Well Name: ESCRITO GALLUP UNIT	Well Location: T24N / R7W / SEC 19 / NENE / 36.304428 / -107.60878	County or Parish/State: RIO ARRIBA / NM
Well Number: 10	Type of Well: OIL WELL	Allottee or Tribe Name:
Lease Number: NMSF080034	Unit or CA Name: ESCRITO GALLUP UNIT	Unit or CA Number: NMNM78390X
US Well Number: 300390542700S1	Well Status: Producing Oil Well	Operator: EPIC ENERGY LLC

Type of Action: Plug and Abandonment

Well: Escrito Gallup Unit 10

# BLM FLUID MINERALS P&A Geologic Report

**Escrito Gallup Unit #10****Current WBD****Proposed P&A****660' FNL & 660' FEL, Section 19, T24N, R7W, Rio Arriba County, NM****API: 30-039-05427**

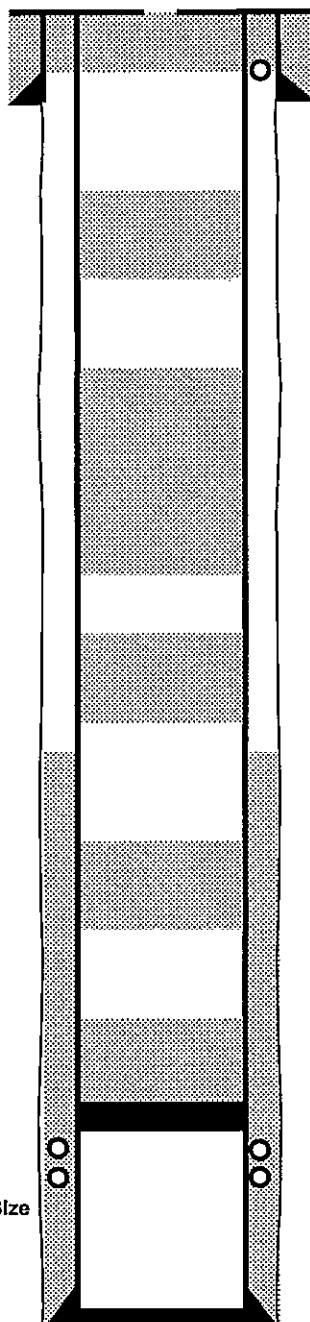
1. Plugging operations authorized are subject to the attached "General Requirements for Permanent Abandonment of Wells on Federal and Indian Lease."
2. The following modifications to your plugging program are to be made:
  - a. Bring the top of Plug #1 (Gallup) up to 5670'.
  - b. Add an inside/outside plug to cover the Chacra formation top at 2988'.
  - c. Adjust Plug #5 (or bring the top of Plug #4 up) to cover BLM picks for the top of the Kirtland (1970') and Ojo Alamo (1820') formations.
  - d. Add an inside/outside plug to cover the surface casing shoe at 422'.
3. Farmington Office is to be notified at least 24 hours before the plugging operations commence (505) 564-7750.

You are also required to place cement excesses per 4.2 and 4.4 of the attached General Requirements.

- BLM picks for the Ojo Alamo and Kirtland formation tops vary from Operator.
- Bring the top of Plug #1 (Gallup) up to 5670'.
- Add an inside/outside plug to cover the Chacra formation top at 2988'.
- Adjust Plug #5 (or bring the top of Plug #4 up) to cover BLM picks for the top of the Kirtland (1970') and Ojo Alamo (1820') formations.
- Add an inside/outside plug to cover the surface casing shoe at 422'.
- The plugs proposed in the P&A procedure, with recommended changes, will adequately protect any freshwater sands in this well bore.
- Gallup perms 5930' – 6104'.
